## DSP-05036-03

Application	General Data	
<b>Project Name:</b> Villages of Savannah  <b>Location:</b> On the west side of Brandywine Road, approximately 5,000 feet north of the intersection of Brandywine Road and Floral Park Road.  <b>Applicant/Address:</b> Mid-Atlantic Builders, Inc. 11611 Old Georgetown Road Rockville, MD 20852	Planning Board Hearing Date:	05/30/19
	Staff Report Date:	05/14/19
	Date Accepted:	03/04/19
	Planning Board Action Limit:	05/27/19
	Plan Acreage:	518.16
	Zone:	R-R
	Dwelling Units:	N/A
	Gross Floor Area:	N/A
	Planning Area:	85A
	Council District:	9
	Election District:	11
	Municipality:	N/A
	200-Scale Base Map:	216SE05

Purpose of Application	Notice Dates	
This case was continued from the Planning Board hearing of May 9, 2019.  Requesting an amendment to revise the recreational facilities and on-site trail network.	Informational Mailing:	02/20/18
	Acceptance Mailing:	02/27/19
	Sign Posting Deadline:	04/09/19

SUBJECT: Detailed Site Plan DSP-05036-03  
Type II Tree Conservation Plan TCPII-149-02-05  
Villages of Savannah

PAVILION AND DOG PARK - MADISON PARK

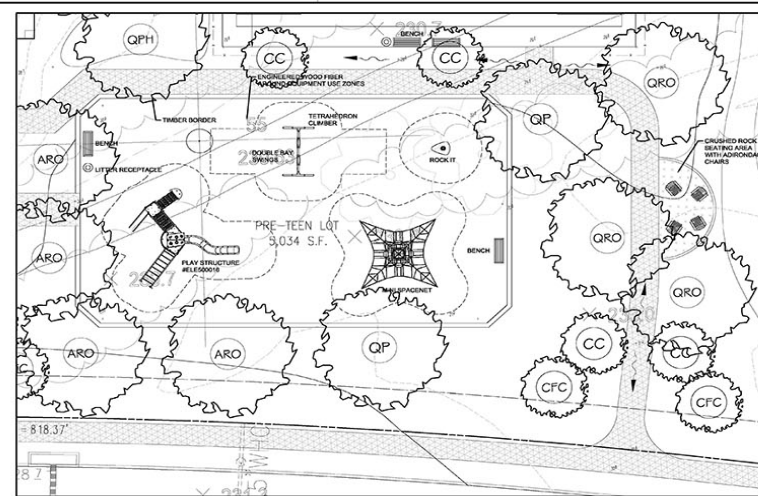
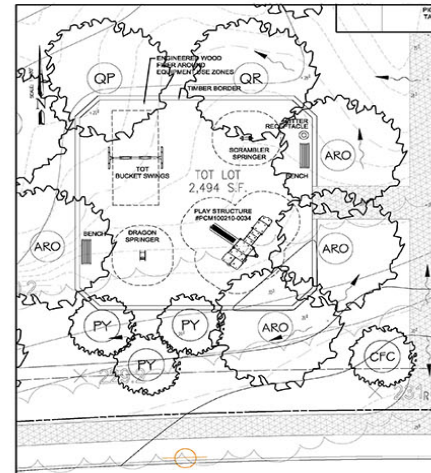
This application seeks to replace the original tennis court with a multiuse court, which staff considers to be of equal value. The relocation of proposed recreational facilities was addressed with the certification of the original DSP.

- (1) Correct the scale shown on the title block to match the scale provided on the plan.
  - (2) Add a note that no lighting will be provided for the proposed recreation facilities on the homeowners association land.
